Oxford Street West and Gideon Drive Environmental Assessment (EA) Study's Environmental
Impact Study (EIS)

Comments from EEPAC on EIS Jan. 12, 2022

Figure 1

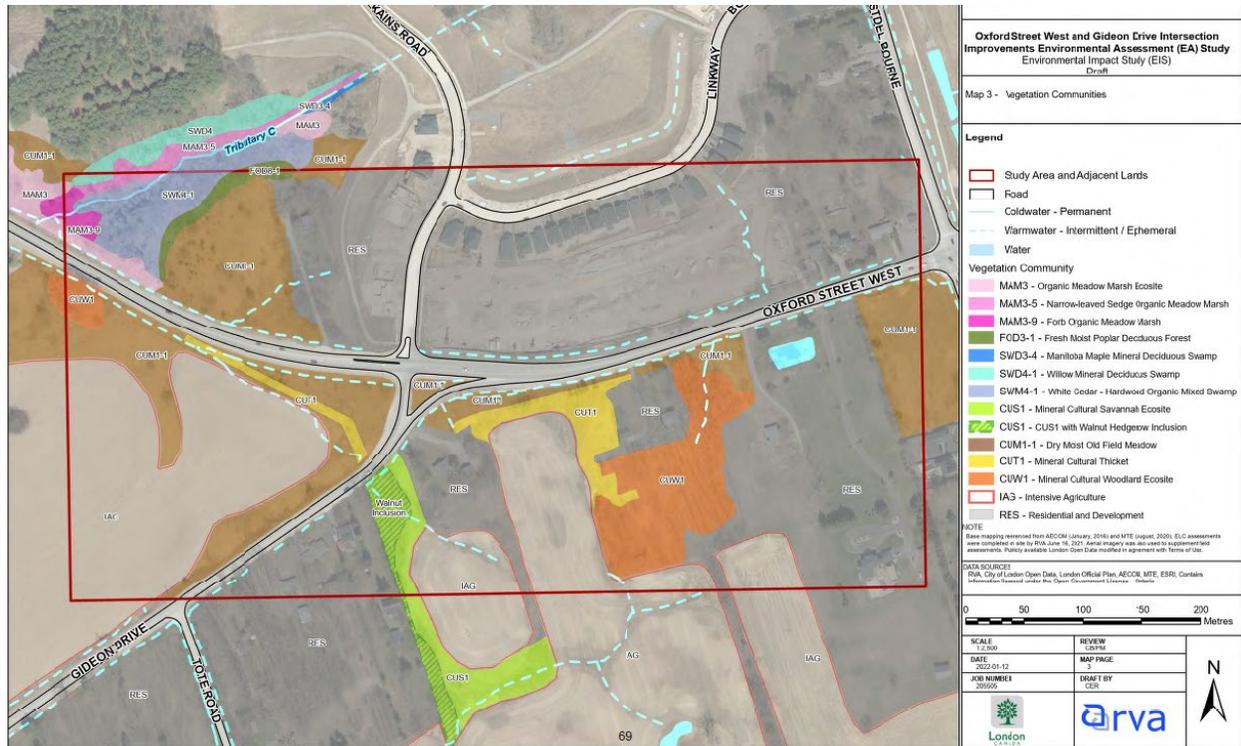
The study area is in an ecologically sensitive area, and within an area of rapid development in the city of London. It is in very close proximity to Kains Woods, an ESA, Tributary C (Figure 1, ~<400 m), a rare, cold-water stream that is connected to the Thames River, and significant valleylands. The proposed intersection improvements are required because of increased traffic volumes and a need to address safety issues resulting from rapid development, limited access to public transportation and opportunities for active transportation. EEPAC's concerns are mainly associated with the potential environmental/ecological adverse impacts on Tributary C, which is the only documented cold water stream in the City of London.

- 2. All stormwater outlets for minor and major flows should be identified on maps in figure 1 or 2 and will require water quality pre-treatment measures and plans for the removal of silt, sediment and salt need to be identified for the existing and/or proposed surface/stormwater discharges into the Tributary 'C' water resources system.*

Figure 2

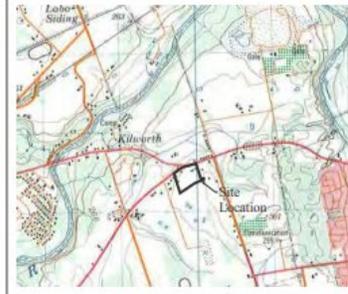
It appears from the air photos (figure 2) that there is a barn on the subject lands. EEPAC recommends a check for Barn Swallow nests/roosts to be undertaken before the structure is removed. If nests are found, it is recommended that a kiosk be built using materials from the old barn be used as compensation. Cole Engineering has a history of successful kiosk construction. <https://www.thespec.com/news/hamilton-region/2017/07/07/inside-ontario-s-fight-to-save-declining-barn-swallows-one-bird-house-at-a-time.html>
